Rev.	Description	Date	Initials
A	Proposed amendments to planning application - creche entrance & location of building.	30/03/23	JJ

Rev. No.	Scale	Date	Drn. By	Chkd. By	Issue
A	1:200 @ A3	20/09/2022	Seán Barrett	Jennifer Lynch	PLANNING - RFI

Project:	Proposed Creche & Community Facility at Cuil Duin Avenue, Cuil Duin, Citywest, Co Dublin		
Title:	PROPOSED SOUTH & EAST ELEVATIONS		
Client:	Greenacre Residential Ltd.		
Dwg. No.	PA-300	Job No.	20040

Project: Proposed Creche & Community Facility at Cull Duin Avenue, Cull Duin, Citywest, Co Dublin  
Title: PROPOSED NORTH & WEST ELEVATIONS  
Client: Greenacre Residential Ltd.

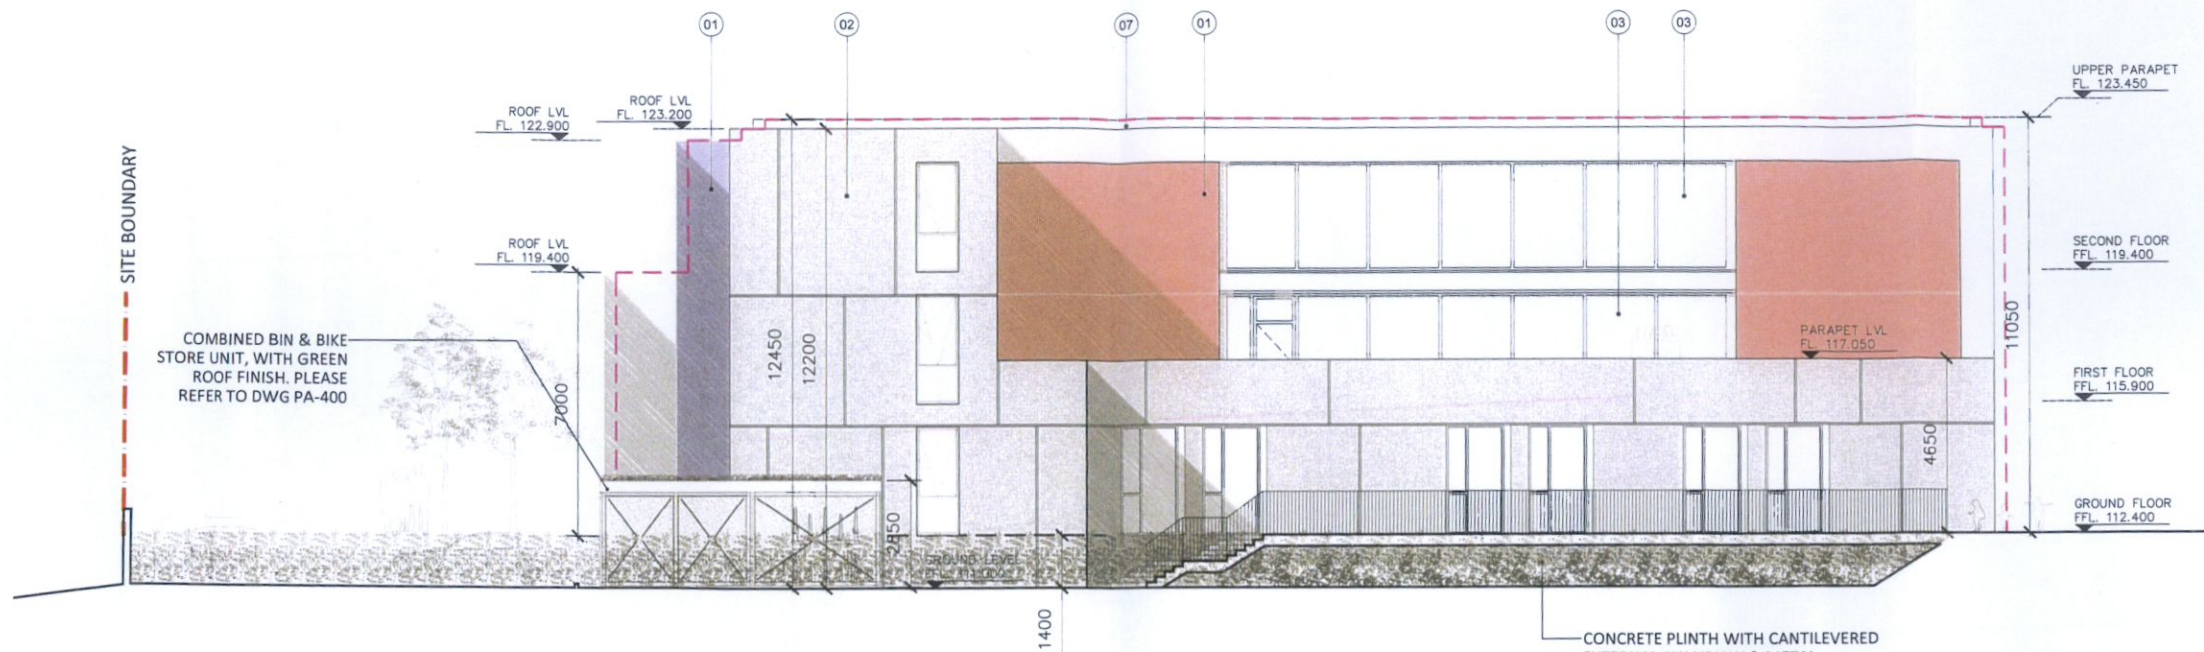
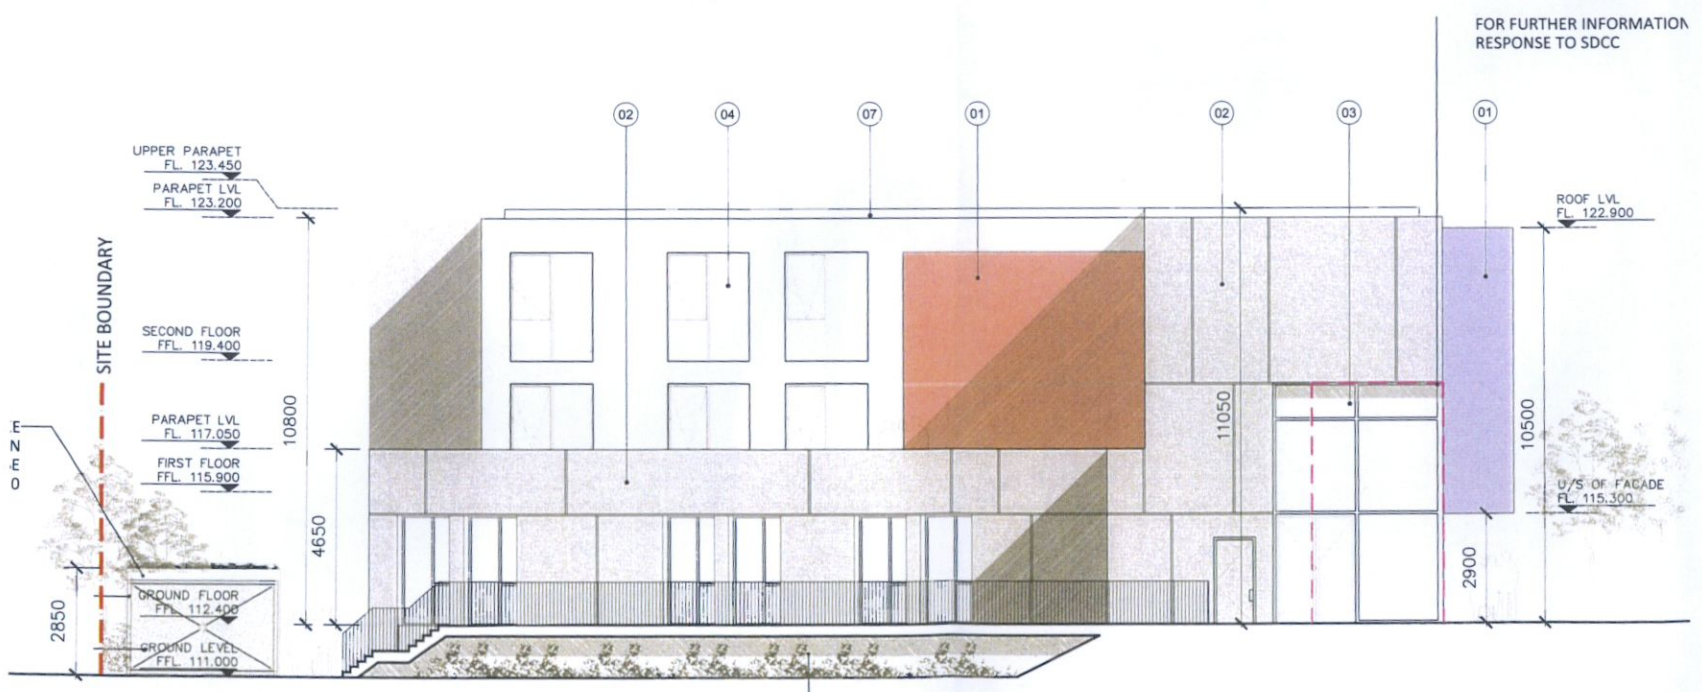
Rev.	Description	Date	Initials
A	Proposed amendments to planning application - creche entrance & location of building	30/03/23	JJ
